## **8.11. Deferred Report - Planning Proposal 1/21 - 270-272 Pacific Highway, Crows Nest**

To present an assessment report for Planning Proposal No. 1/21 at 270-272 Pacific Highway, Crows Nest after its consideration by the Local Planning Panel on 29 September 2021.

Council received a Planning Proposal to amend North Sydney Local Environmental Plan 2013 (NSLEP 2013) as it relates to land at 270-272 Pacific Highway, Crows Nest.

**Figure 17. Lower ground level with internal courtyard areas (Source: fitzpatrick + partners 2021).**

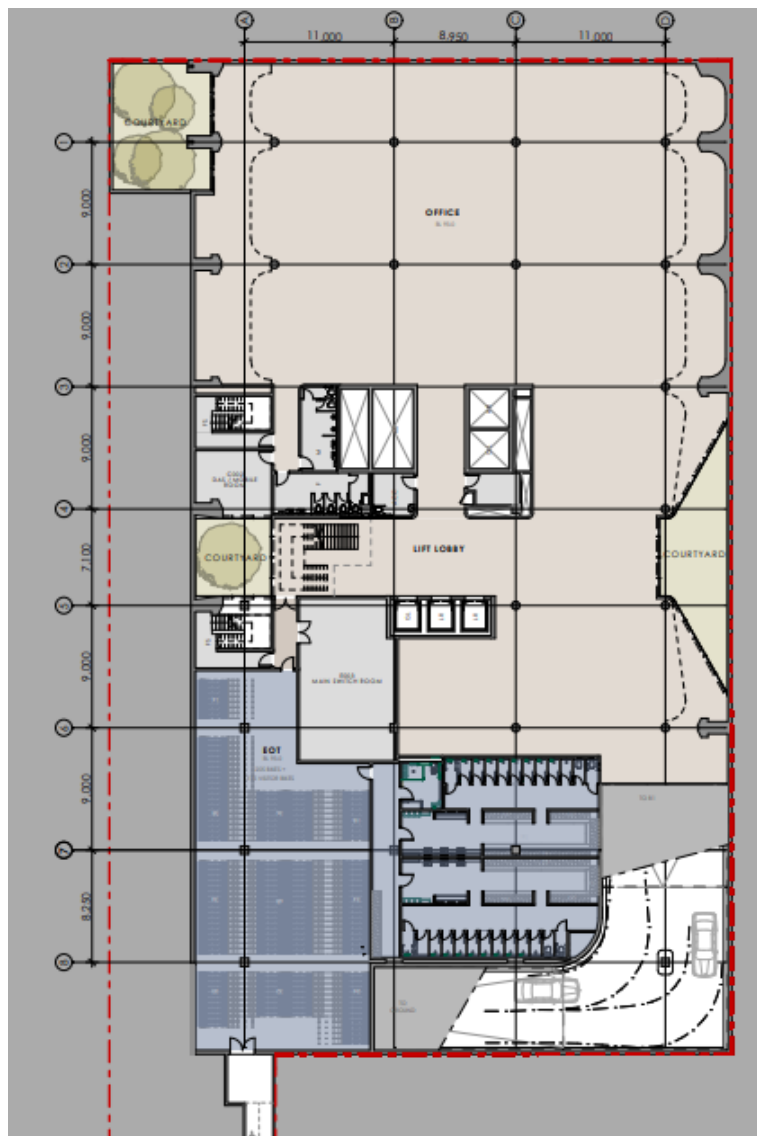
In this instance, the additional below-ground FSR sought is considered to be appropriate as it will result in a built-form outcome that does not create additional amenity impacts, will have adequate light and ventilation and will provide additional commercial floorspace in line with the objectives of the 2036 Plan.

**Figure 18. Eastern elevation of concept scheme (Source: fitzpatrick + partners 2021).**

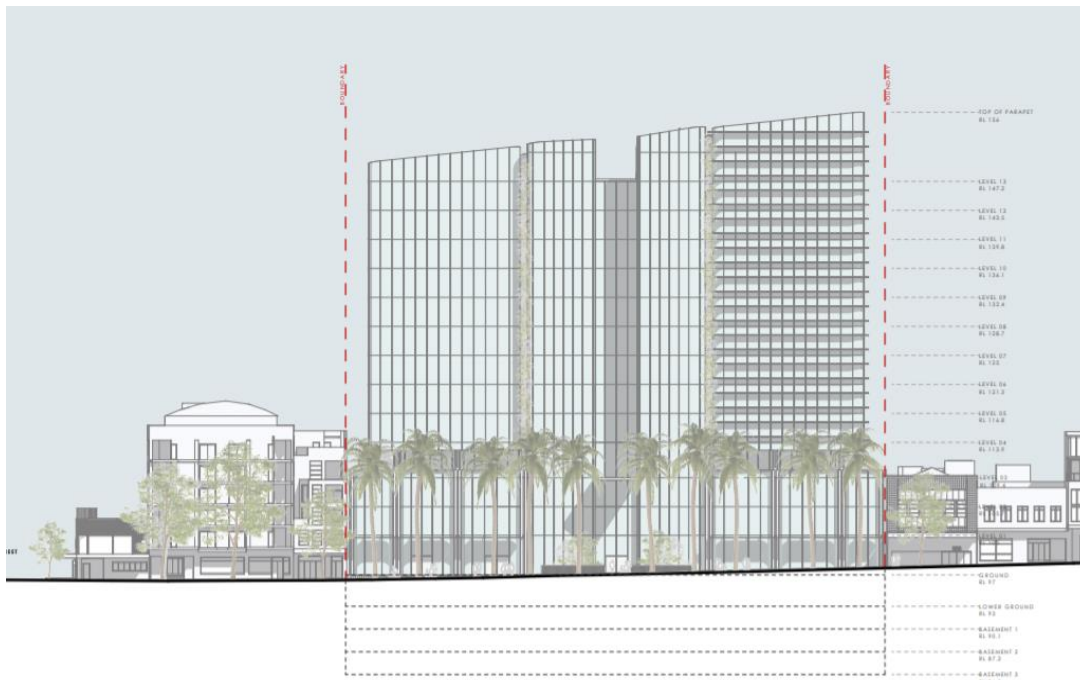
The concept scheme shows a building with a height of up to RL156 (59m) at its highest point, with the building reducing in height towards the south and west (figure. 18). The scheme shows somewhat typical floor to floor heights for a commercial tower, with most floors showing a floor-to-floor height of 3.7m. However, the scheme shows the ground level with floor-to-floor heights of 5m, podium plant level with height 4.5m and the upper rooftop plant level showing a height of approximately 8.8m.

The ground level and mid-plant floor-to-floor heights are relatively common and not considered to be an issue. With respect to the roof plant level, it is considered that a height of 8.8m is excessive, ultimately resulting in a building higher than what would be expected for a 13-storey commercial tower.

For the reasons outlined in this report, it is recommended that Council support the progression of the Planning Proposal to the DPIE seeking a Gateway Determination, noting a reduction in height from 59m to 54m and the recommendation for site-specific DCP provisions to be prepared to help guide future detailed design and development application assessment process.

Figure 20 - Building relationship as viewed from the south (Source: fitzpatrick + partners 2021).

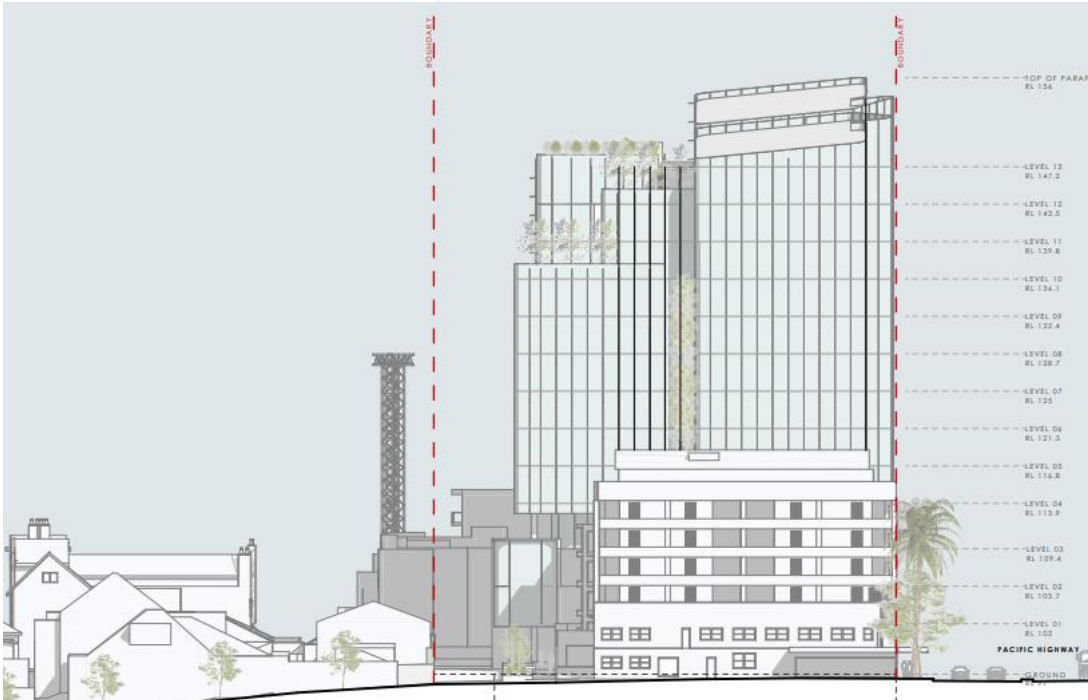
The Plan includes the 'transition and interfaces' principle, which makes references to the fact that height transitions should be sought for development adjacent to lower scale areas. The concept design included with the proposal shows a 'stepping' of the built form at higher levels. The applicant has provided the following comment on the building transition, with such transition shown in the proposed setbacks in figures 19 and 20.

Whilst it is observed that the interface or physical spatial relationship between the existing low density residential and that proposed is dramatic, this is difficult to entirely avoid considering the vast difference in allowable heights between the sites as stipulated under the 2036 Plan. The Pacific Highway is identified as a major development corridor in the area, with other sites along Pacific Highway earmarked to present comparable transitions and interfaces to what is proposed. In light of the proposal being compliant with the building envelopes envisaged by the 2036 Plan and considering the future heights and density identified along the corridor and throughout the precinct, the proposed building transition or interface to the rear in this instance is considered to be acceptable in this context.

**Figure 21. Overshadowing resulting from the proposal. (Source: fitzpatrick + partners 2021)**

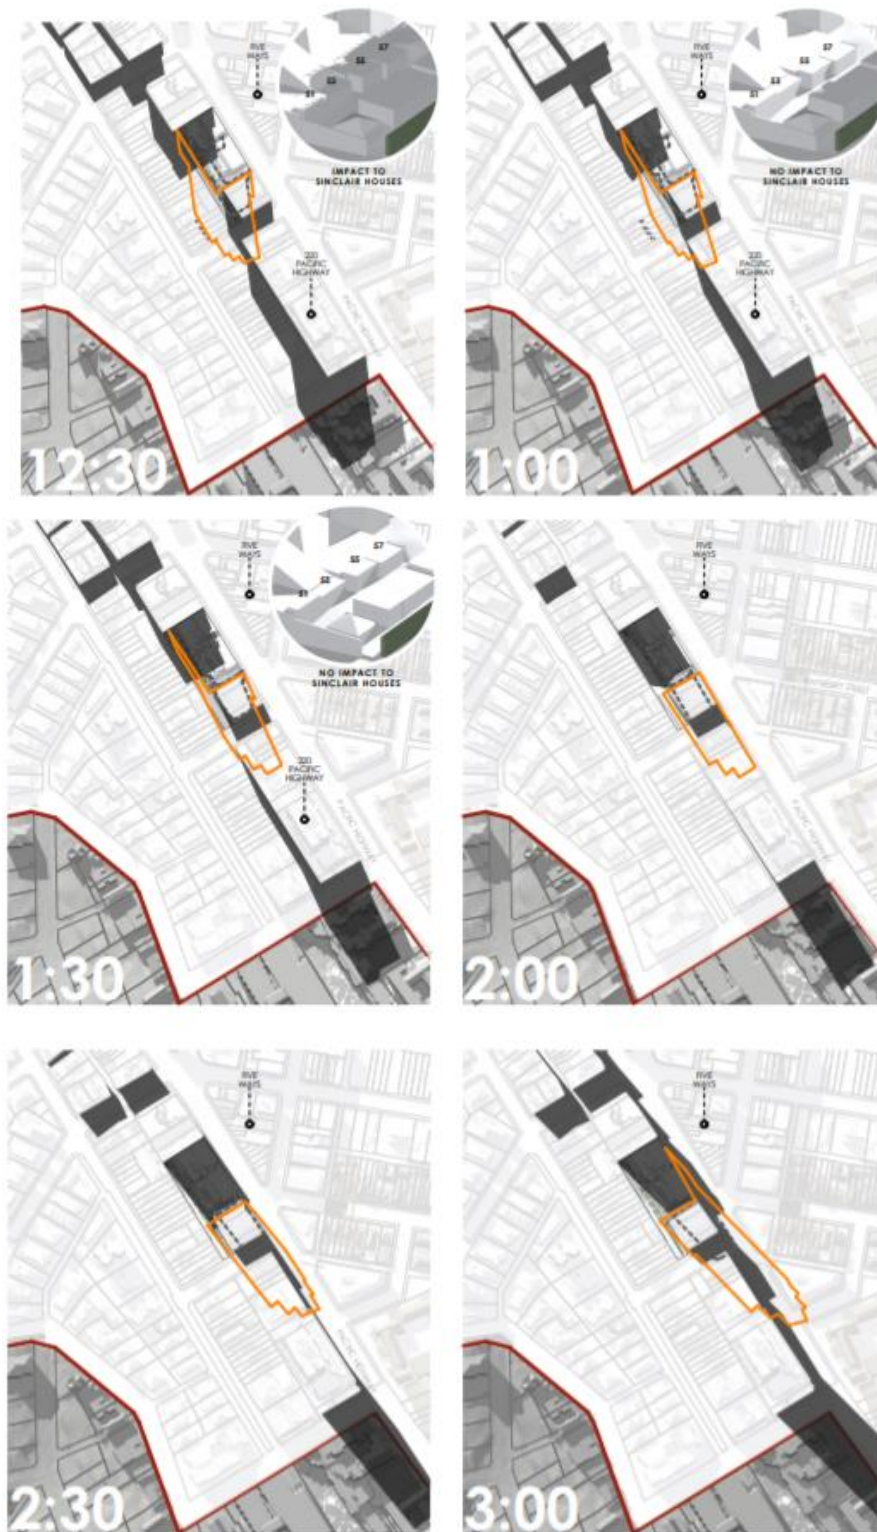
The proposal states that it complies with the 2036 Plan's solar access requirements for residential areas inside the precinct boundary to the extent that these residential areas still achieve the minimum required 2 hours solar access between 9am – 3pm. The applicant's Urban Design Report includes shadow diagrams which indicate that there will some minor overshadowing still on the rear yards of properties to the west of the site between 1pm and 1:30pm. These sites will in mid-winter, be largely in shadow prior to this time. Below are extracts from the accompanying reference design provided by the applicant.
